DEVIATION REVIEW AND DECISION FORM

Subdivision or Project Name: Flying Horse at Shamrock Ranch

Address of Subject Property (Street Number/Name): N/A
Tax Schedule ID(s): #5100000334 plus other adjacent parcels
Legal Description of Property: NW4, NW4NE4, S2NE4, NW4SW4 SEC 31-11-65
Subdivision or Project Name: Flying Horse North at Shamrock Ranch

Section of ECM from Which Deviation is Sought: 2.2.5.B.1 Rural and Urban Principal Arterial and Rural Minor Arterial Access Criteria Spacing.

Figure 1
Black Forest Road Intersection/Access Spacing
 Flying Horse North (LSC #164050)

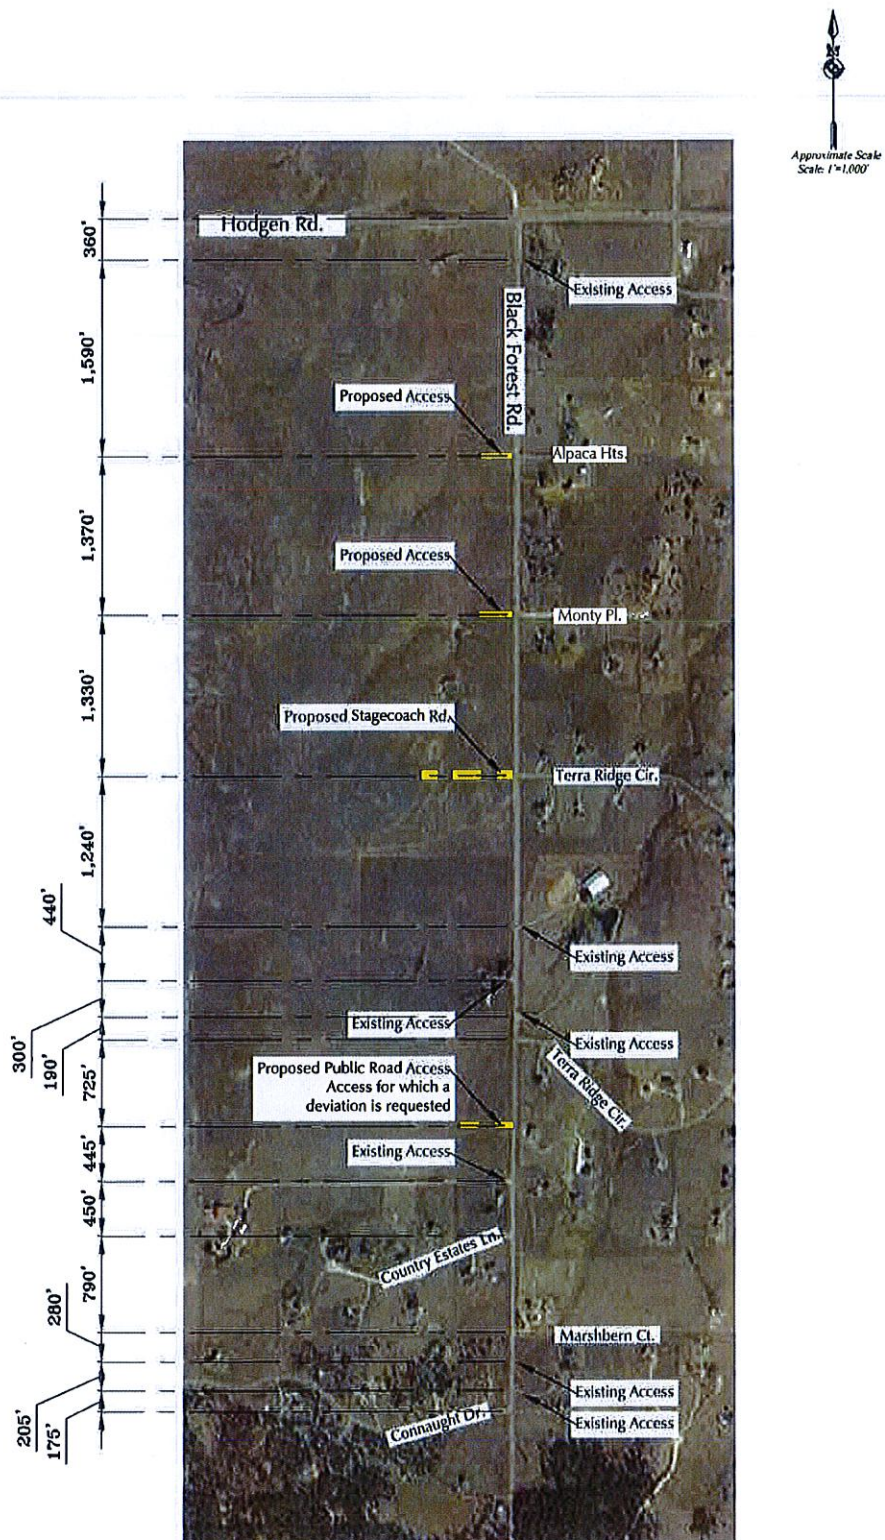
Proposed Nature and Extent of Deviation: The modification is requested to allow a proposed full-movement access to Black Forest Road (Rural Minor Arterial) 725 feet south of Black Forest Road/Terra Ridge Circle (south). This is 595 feet closer than the required one-quarter mile (1,320 feet) spacing. However, this would create two offset "T" intersections instead of one four-leg intersection, which in this situation would be preferable from a traffic operations and safety standpoint. The applicant will provide future access for parcel 5100000080 if/when the parcel is subdivided to eliminate the need for a continued access to Black Forest Road in the current driveway location.

Proposed Nature and Extent of Deviation: Please refer to the attached intersection/access spacing and sight distance exhibits. Proposed full-movement access to Black Forest Road (Rural Minor Arterial), 725 feet south of Black Forest Road/Terra Ridge Circle (south). This is 595 feet closer than the required one-quarter mile (1,320 feet) spacing. However, this would create two offset "T" intersections instead of one four-leg intersection, which in this situation would be preferable from a traffic operations and safety standpoint. The applicant will provide future access for parcel

Comparison of Proposed Deviation to ECM Standard: The access is proposed to be 595 feet closer than the required one-quarter mile (1,320 feet) spacing to the intersection to the north and about 430 feet closer than the quarter-mile spacing to the south.

Figure 2

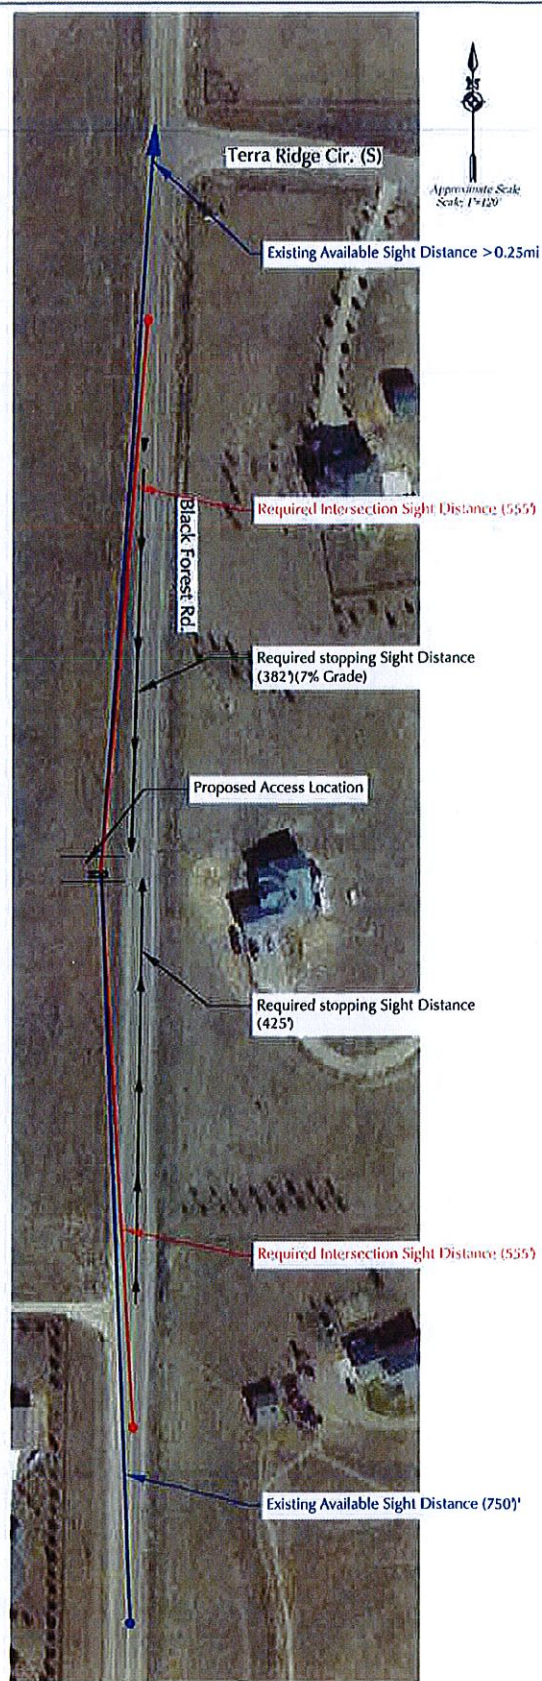
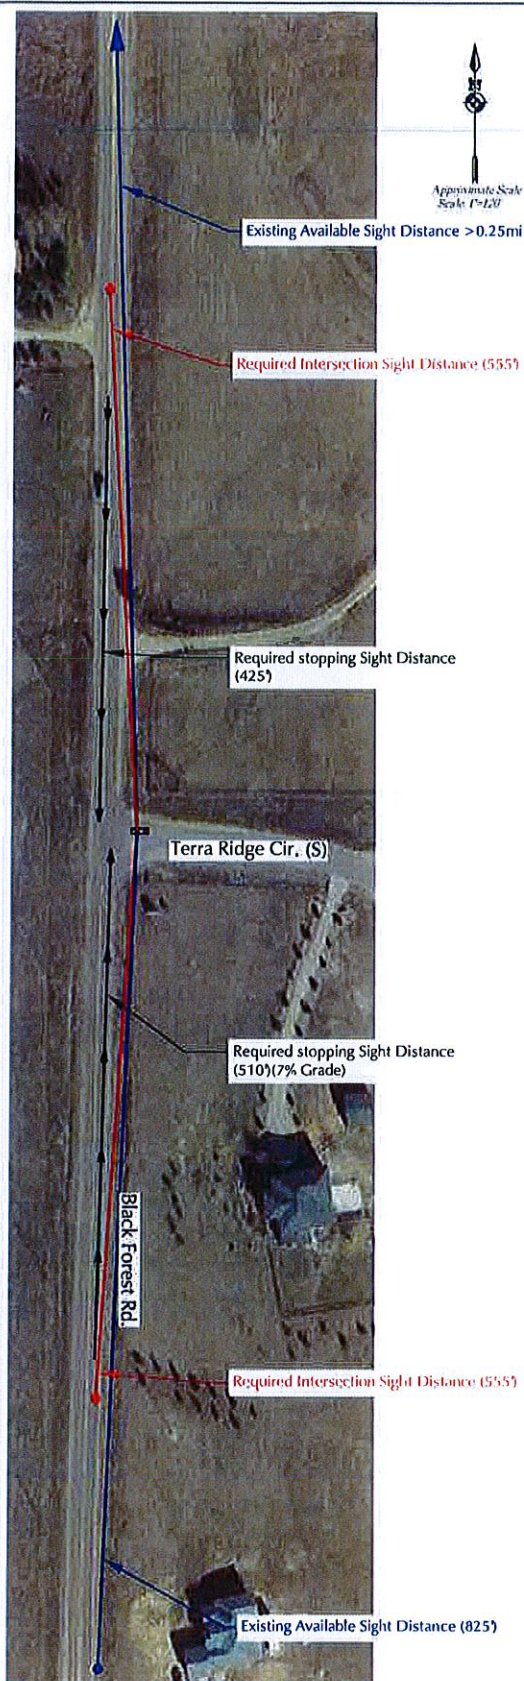
The location for the access has been selected as the preferred location for several reasons. It would result in a more than adequate intersection and stopping sight distance and shorter vehicle stopping distance when compared to the location across from Terra Ridge Circle (south) with the access proposed for the crest of the vertical curve instead of the bottom of the vertical curve. The access placement in this location would not interfere with any existing or proposed auxiliary turn lanes. The access spacing north to Terra Ridge Circle (south) and south to Country Estates Lane would be sufficient for safe operations and turning movements. This access would not require any auxiliary turn lanes. Also, a significant benefit to the request would be that the intersection would be a T intersection configuration and the existing intersection to the north would also remain a T intersection. The T intersection configurations would have fewer vehicle conflicts than a four-leg intersection at Terra Ridge Circle (south). The current left turn from existing Terra Ridge Circle (south) would have lower delay and the intersection would have significantly fewer conflict points than if a four-leg intersection were created at this location.

Please refer to the attached intersection/access spacing and sight distance exhibits. The location for the access has been selected because it would result in a more than adequate intersection and stopping sight distances and shorter vehicle stopping distance when compared to the location across from Terra Ridge Circle (south) with the access proposed for the crest of the vertical curve instead of the bottom of the vertical curve. The access placement in this location would not interfere with any existing or proposed auxiliary turn lanes. The access spacing north to Terra Ridge Circle (south) and south to Country Estates Lane would be sufficient for safe operations and turning movements. This access would not require any auxiliary turn lanes. Also, a significant benefit to the request would be that the intersection would be a T intersection configuration and the existing intersection to the north would also remain a T intersection. The offset T intersection configurations would have far fewer vehicle conflicts than a four-leg intersection at Terra Ridge Circle (south). According to NCHRP 500 Strategy 17.1. B4, (conversion of a 4-legged intersection to two offset T intersections), collision rates at a pair of two offset T intersections have been shown to have crash rates of 37 to 43 percent of the rates at a single, four-leg intersection with four approaches. There are certain conditions when offset T intersections should not be implemented, but for intersections such as the proposed intersection with what would be very low straight through volumes on the minor street, the offset T would be a better solution. Overall, the proposed offset T intersection access configuration would be preferable to a four-leg intersection created at the bottom of a seven percent downgrade. The provision for a shorter vehicle stopping distance with an uphill grade on the approach to an intersection would be preferable.
